**REDLINE**

## **Teanaway Solar Reserve**

# **Conditional Use Permit Application Supplement and Expanded SEPA Checklist Supplement**

**FEBRUARY 2010**

**FIGURE 3**  
**Site Access Map**  
Teanaway Solar Reserve  
Kittitas County, Washington

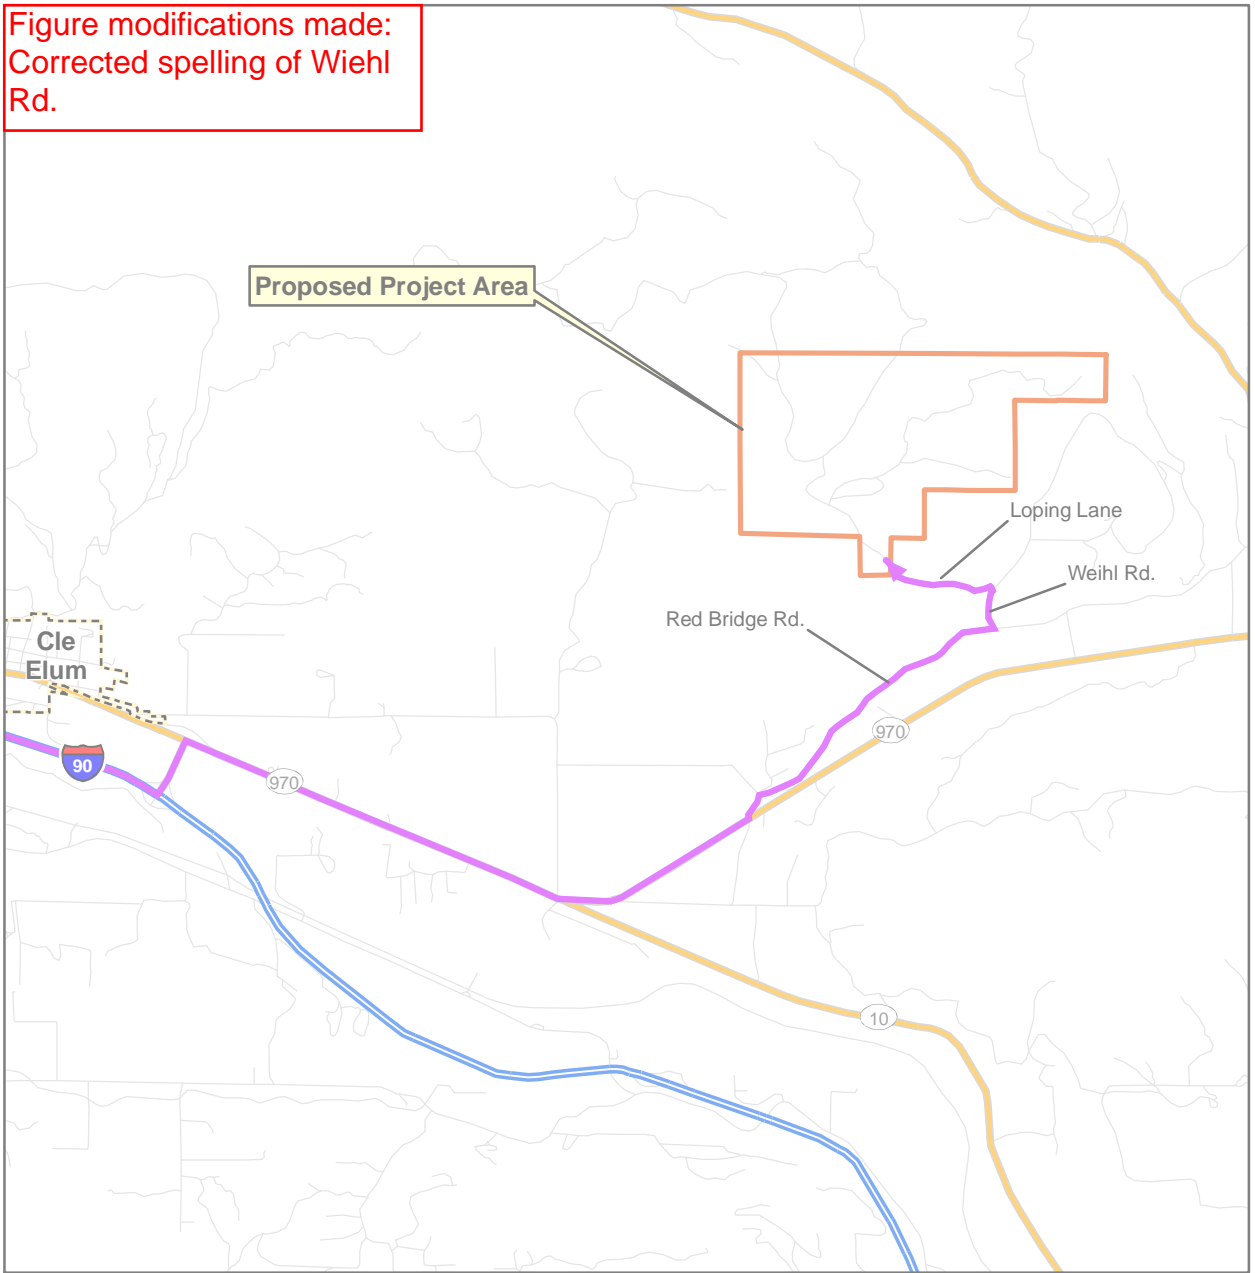
Figure modifications made:  
Corrected spelling of Wiehl Rd.

**FIGURE 4**  
**Identified Structure Map**  
 Teanaway Solar Reserve  
 Kittitas County, Washington

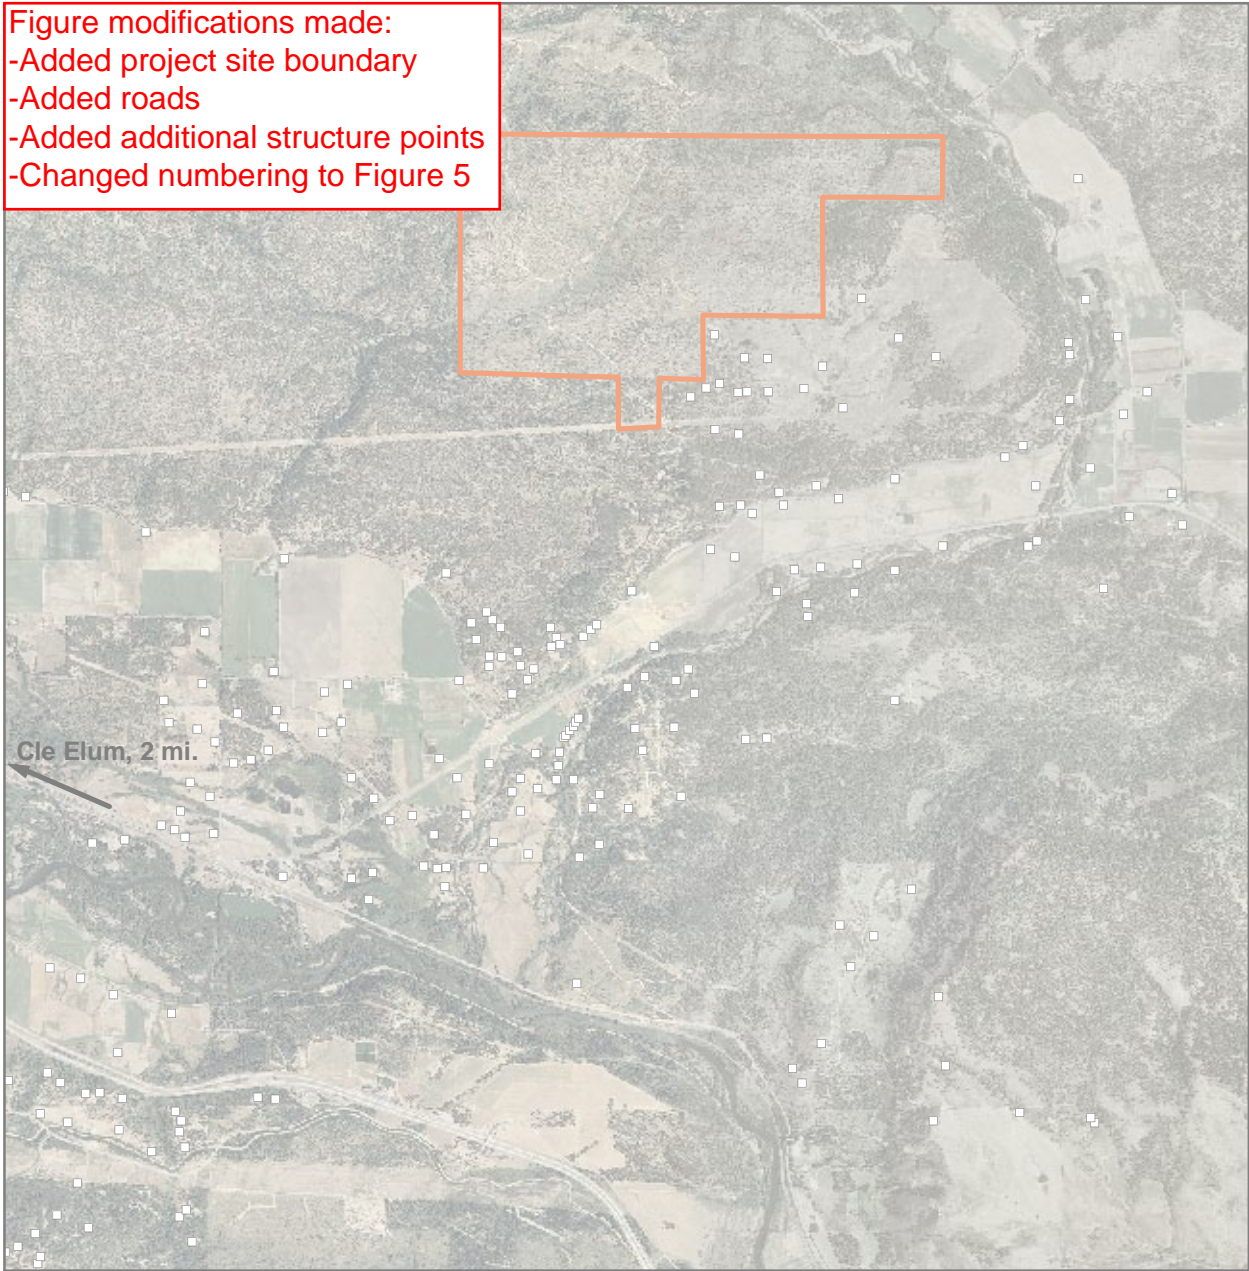
Figure modifications made:  
 -Added project site boundary  
 -Added roads  
 -Added additional structure points  
 -Changed numbering to Figure 5

**FIGURE 5**  
**Conceptual Site Layout**  
 Teanaway Solar Reserve  
 Kittitas County, Washington

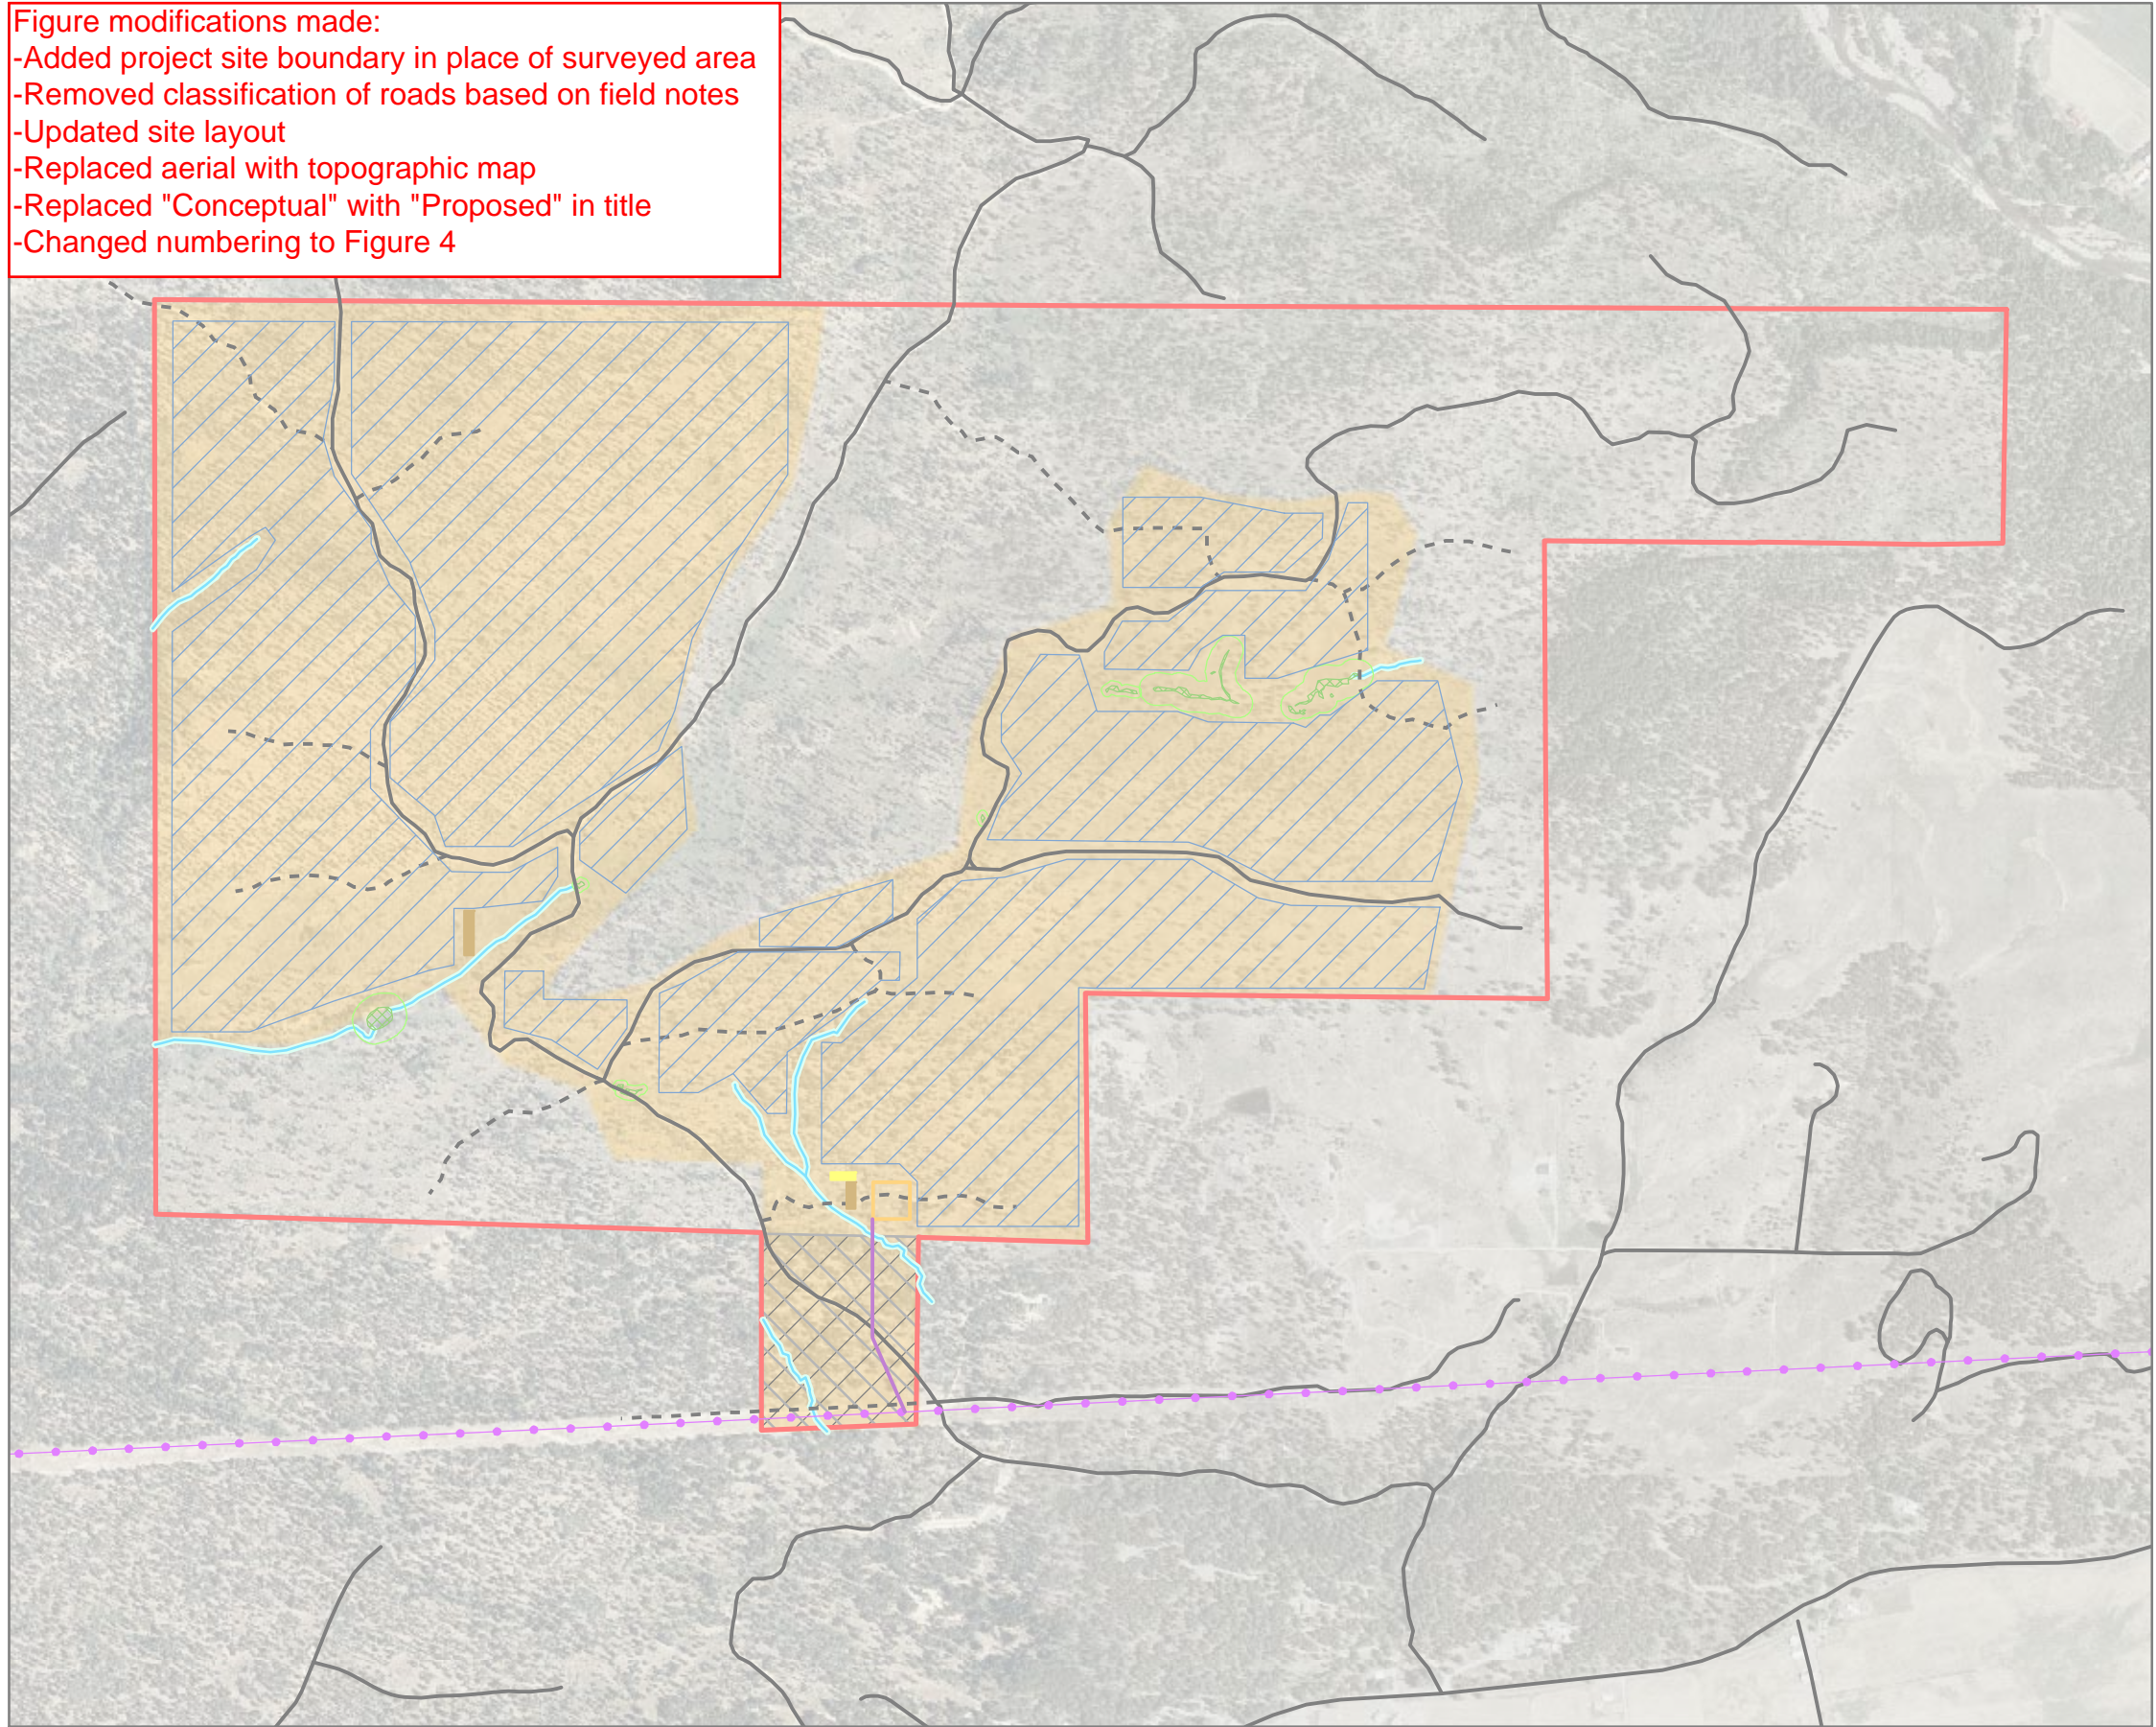
Figure modifications made:  
 -Added project site boundary in place of surveyed area  
 -Removed classification of roads based on field notes  
 -Updated site layout  
 -Replaced aerial with topographic map  
 -Replaced "Conceptual" with "Proposed" in title  
 -Changed numbering to Figure 4

**FIGURE 8**  
**Designated Critical Areas:**  
**Aquifer Recharge Areas**  
 Teanaway Solar Reserve  
 Kittitas County, Washington

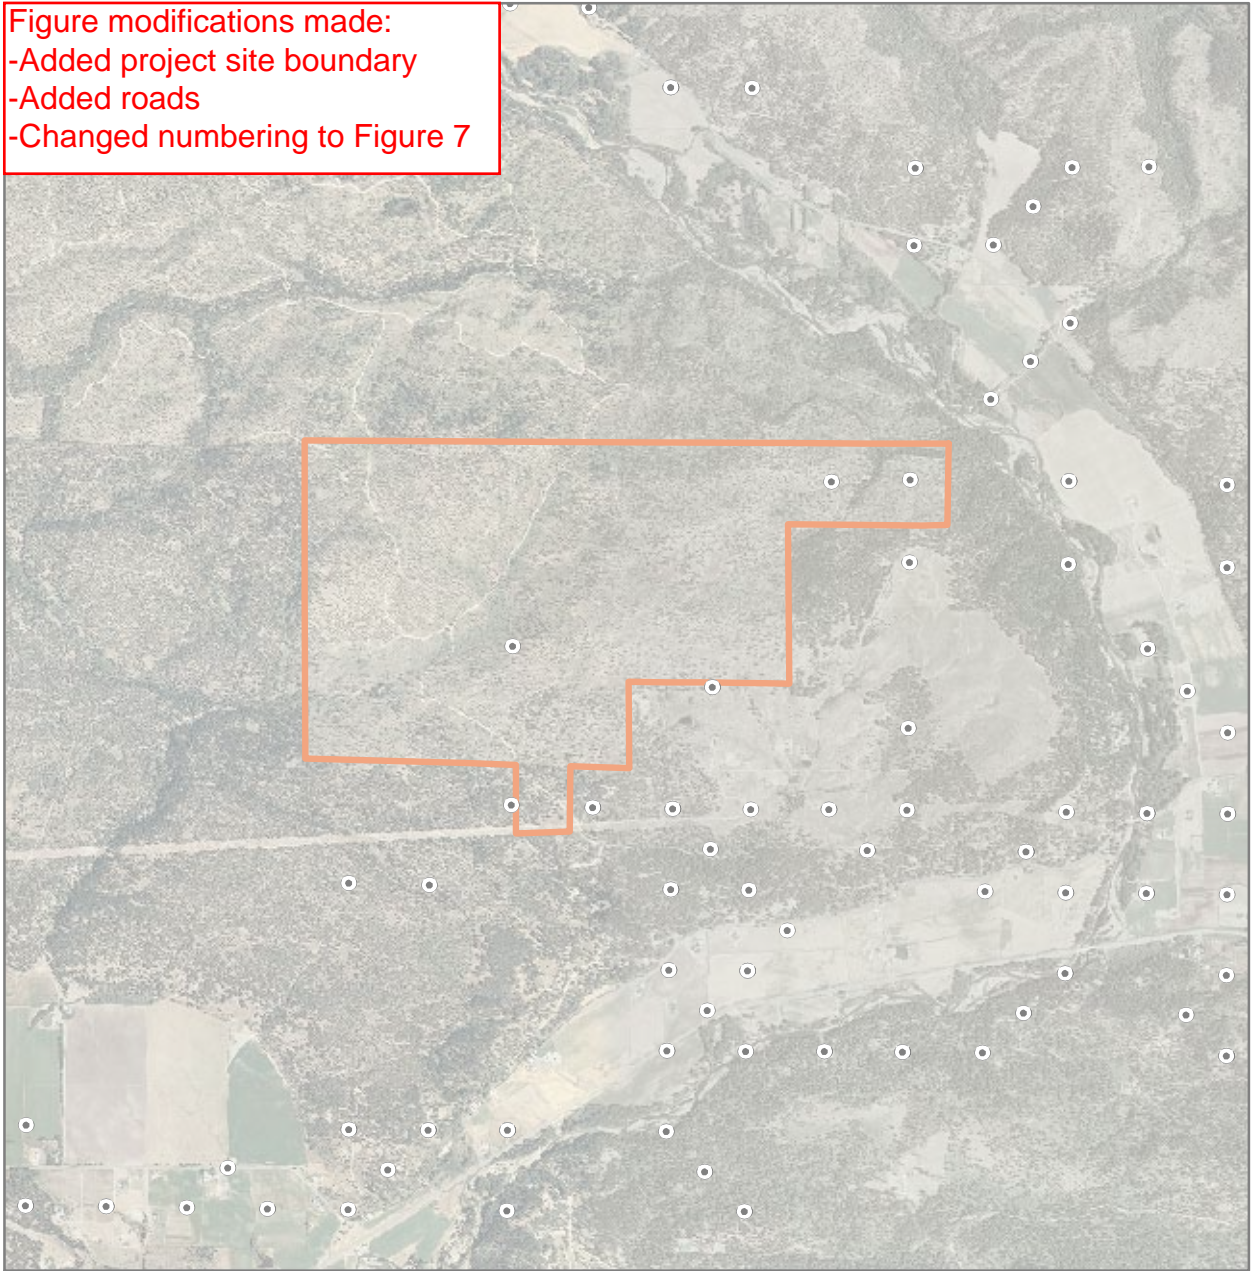
Figure modifications made:  
 -Added project site boundary  
 -Added roads  
 -Changed numbering to Figure 7

**FIGURE 3**  
**Habitat Types**  
 Sensitive Species Surveys Report  
 Teanaway Solar Reserve  
 Kittitas County, Washington

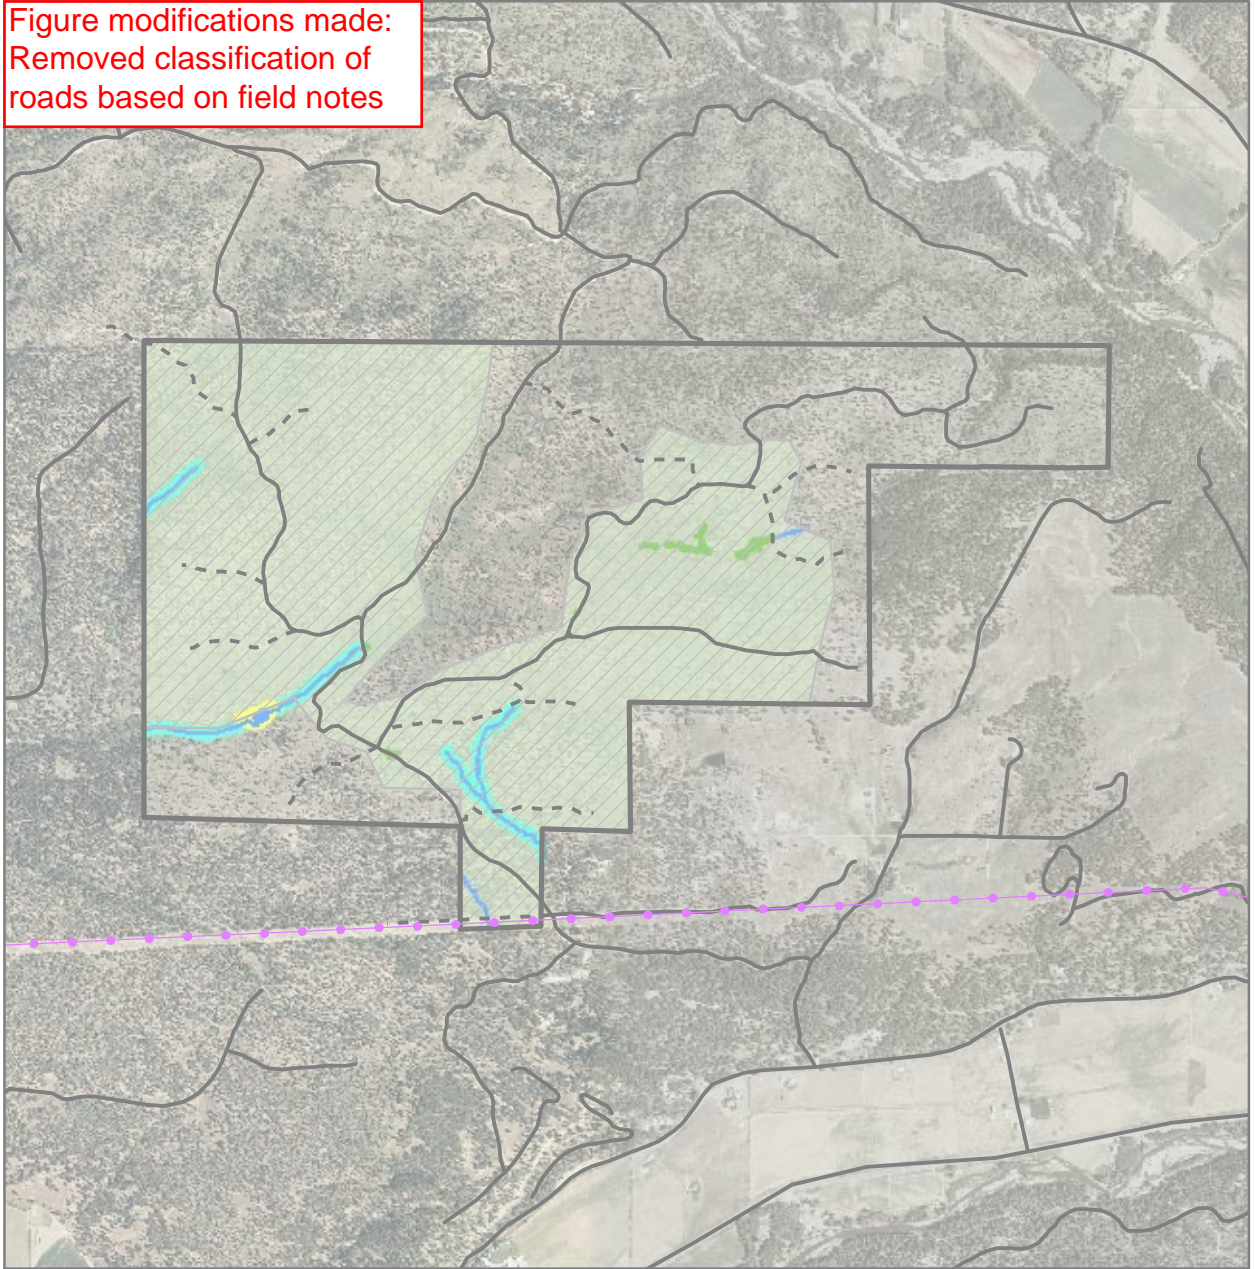
Figure modifications made:  
 Removed classification of roads based on field notes
